# SERVICE BULLETIN

NO. 61-42

SERVICING  
THE  
ELECTRIC  
ANTENNA

ALL 1961  
CHRYSLER  
AND  
IMPERIAL  
ELECTRIC  
ANTENNA  
EQUIPPED  
MODELS

FIGURE 1 - DISASSEMBLED ANTENNA

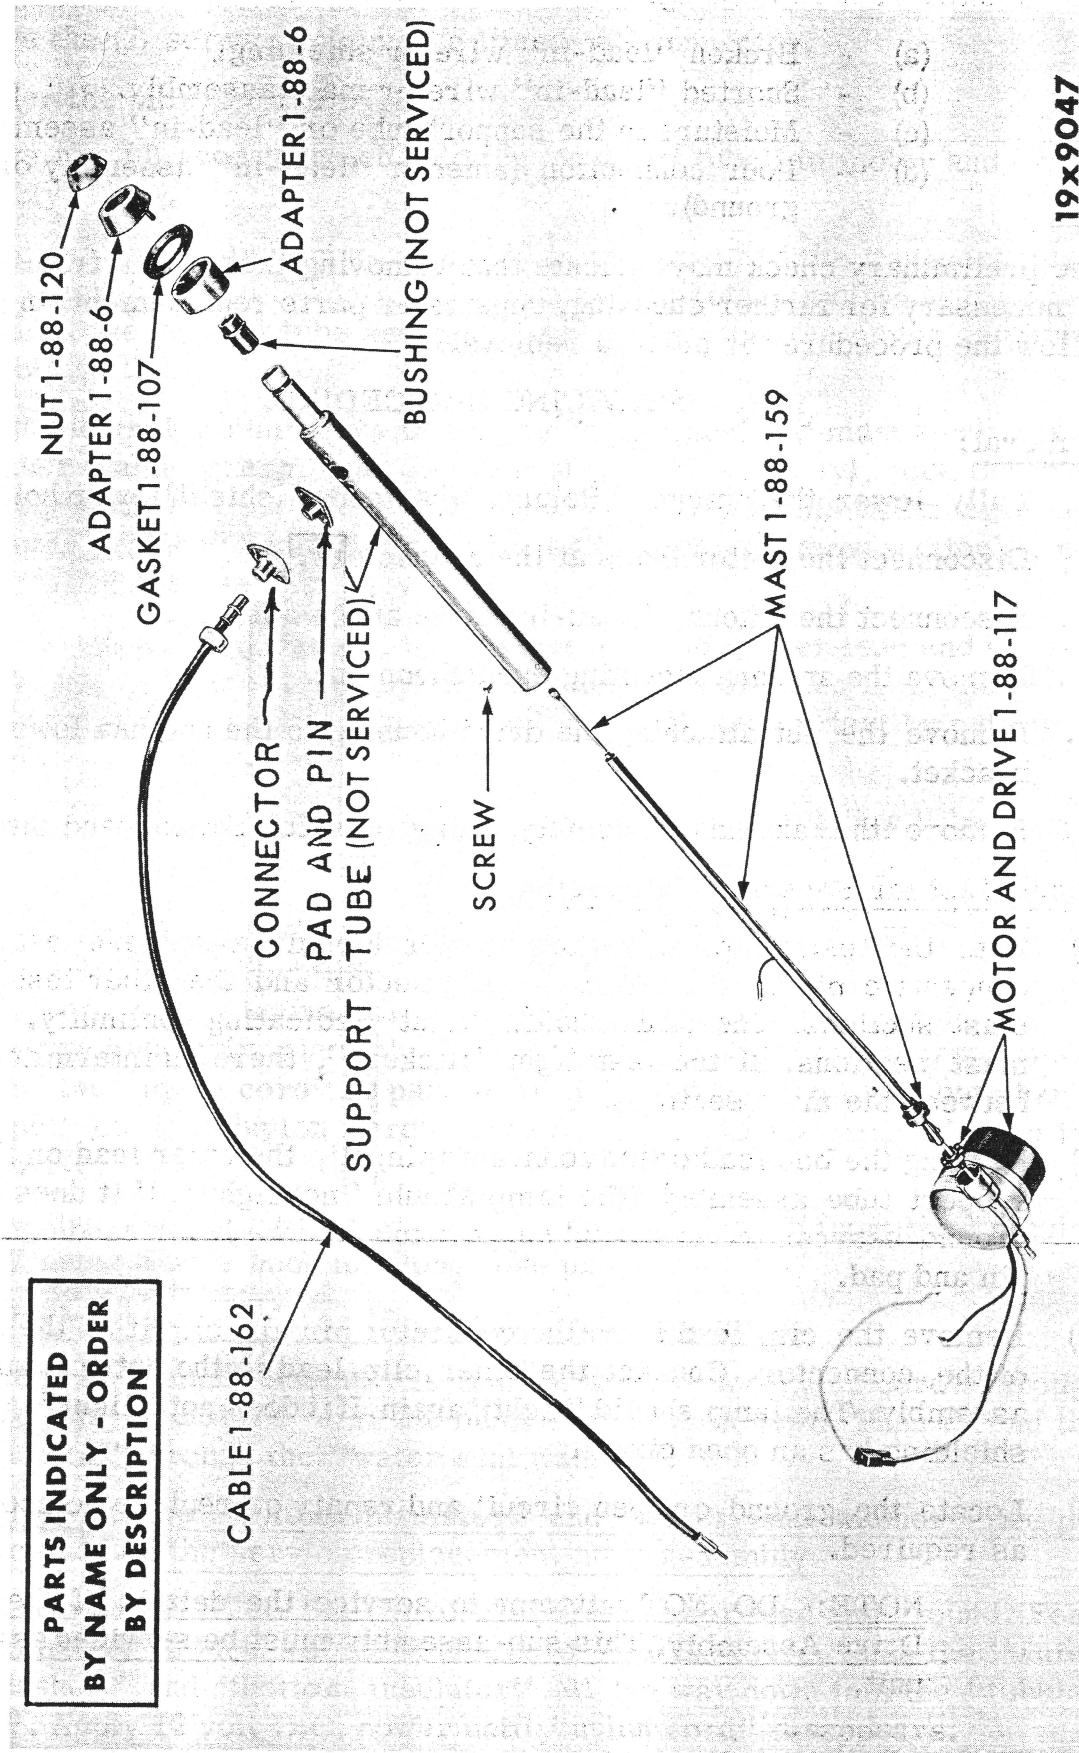
A change was incorporated in 1961 Chrysler and Imperial models equipped with the electric radio antenna, starting with Chrysler Serial Number 13114849 with prefixes 81, 82, 83, 84, 85, and 87, and Imperial Serial Number 14102617 with prefixes 91, 92, and 93. This change consists of a "new" electric antenna assembly with the drive mechanism "concentric" with the motor. The antennas used prior to the serial numbers listed had an "angle drive mechanism".

The main components of the new electric antenna are the motor and drive assembly, the mast assembly, and the support tube assembly. The antenna is serviced as a mast assembly, motor and drive assembly, connector, and pad and pin assembly, "lade-in" assembly and the necessary switches.
